**Task Force Meeting - January 18-19, 2010**

**SGS-8 – January 20-22, 2010**

#### Global technical regulation No. xx

HYDROGEN POWERED VEHICLE  
Established in the Global Registry on [DATE]

Figure 1. Example of High-level Schematic of Key Systems in FCVs

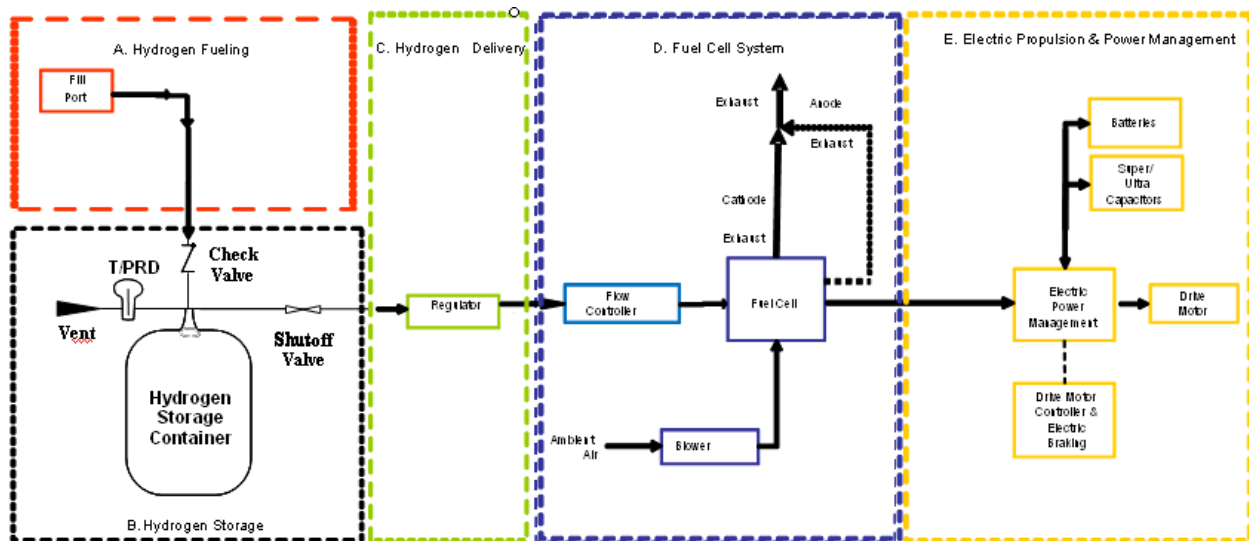
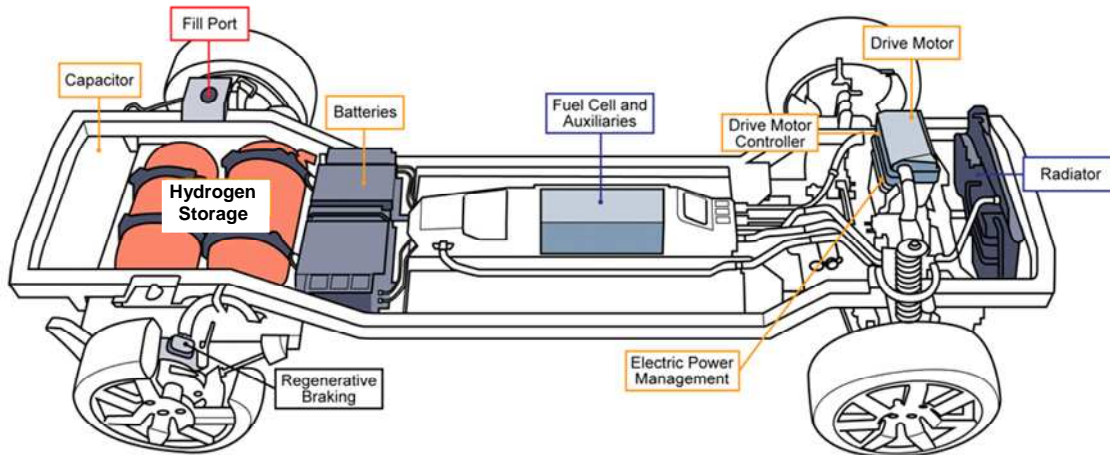
▶▶ SGS-8 OICA comment #1: In case of LH2 extraction of liquid hydrogen should be also allowed. According to Figure 4 the coolant heat exchanger does not contain to the LH2 storage system.

- SGS-8 increase text size

**Figure 4.** Typical Liquefied Hydrogen Storage System

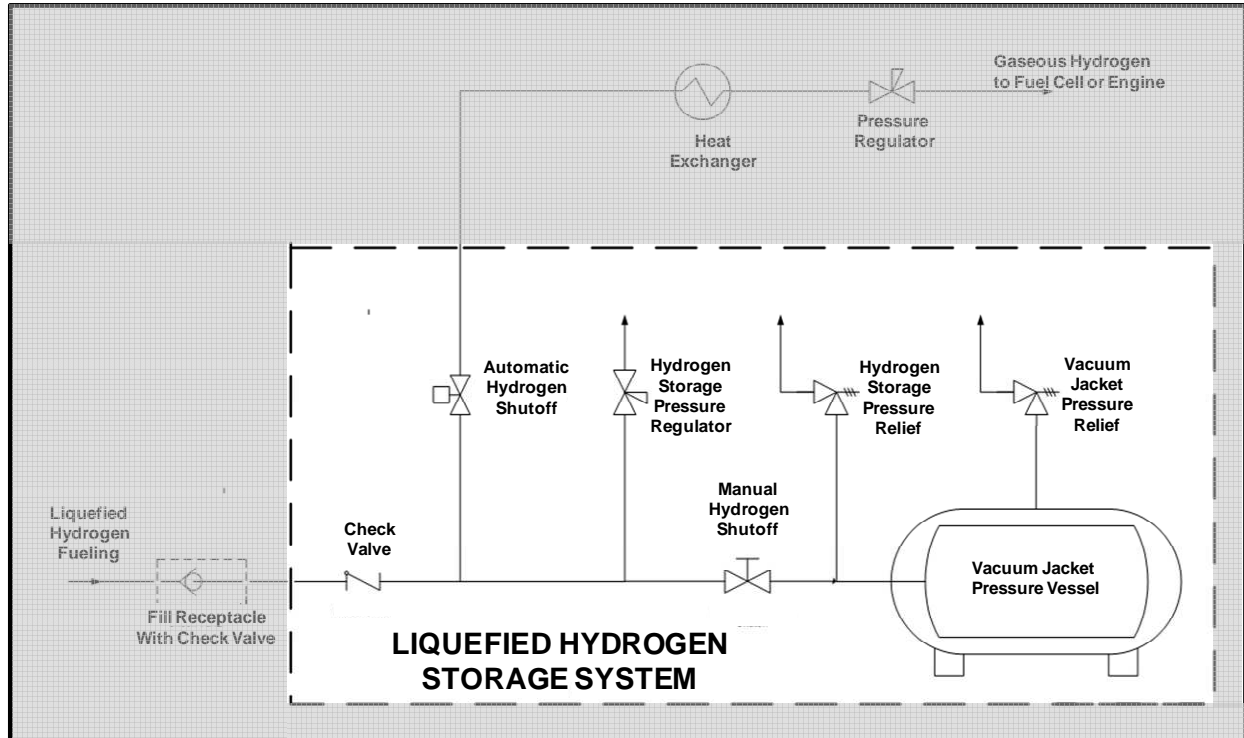
▶▶ *SGS-8 OICA(BMW) comment #7 – proposed text revisions highlighted in 3.3.2 text -- except proposal for deletion of check valve -- SGS discussion is required -- also except Fig 4 (but content of figure change is included in GWS comment #7 figure)*

▶▶ *SGS-8 GWS comment #7: text proposal of similar content to OICA #7&8 and Germany #5 (except check valve); figure revision proposed*

↗ **SGS-8 Germany comment #6: move a PRV to downstream of shut-off valve in figure**  
-- text & figure accommodate Germany comments

▶▶ SGS-8 OICA comment #1: According to Figure 4 the coolant heat exchanger does not contain to the LH2 storage system.

Figure B.5.1.1 Generic Hydrogen Storage System

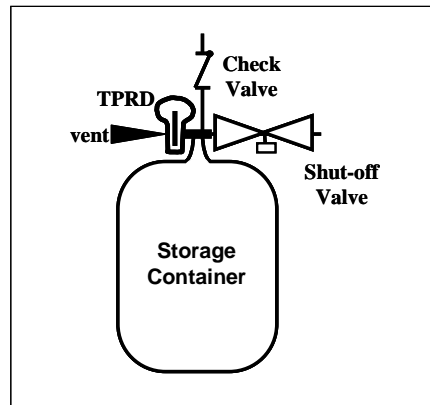
B.5.1 This section specifies the requirements for the integrity of the compressed hydrogen storage system. As illustrated in Figure B.5.1.1, the hydrogen storage system consists of the high pressure storage container(s) and closures of openings into the high pressure storage container(s). Closures include the temperature-activated pressure relief device(s) (TPRD), check valve(s), shut-off valve(s) and all components, fittings and fuel lines that isolate the high pressure storage system from the remainder of the fuel system and environment. **The check valve, shut-off valve and TPRD(s) shall be mounted directly on or within each container.**

TFG – agreement with Japan’s proposal.

SGS-8: OICA raised reservation. The rationale will be provided in part A.

Figure B. 5.1.2 Verification Test for Performance Durability (hydraulic)

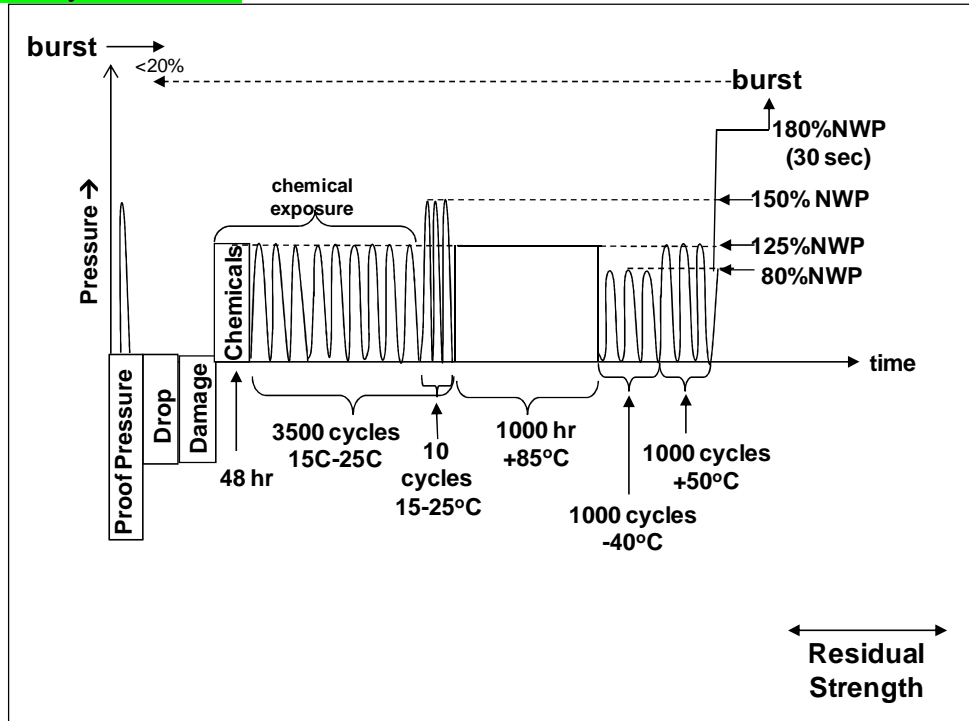
SGS-8 ISO comment #12: A boss torque test should be included for composite tanks with non load sharing liners.

TFC – change the last 1000 cycles to 85C.

TFG – OICA will provide a rationale in part A for not including the boss torque requirement. Need to address the leakage up stream of the shut-off valve.

SGS-8: Not include boss torque test in part B. OICA will provide rationale in part A. Japan raises a study reservation.
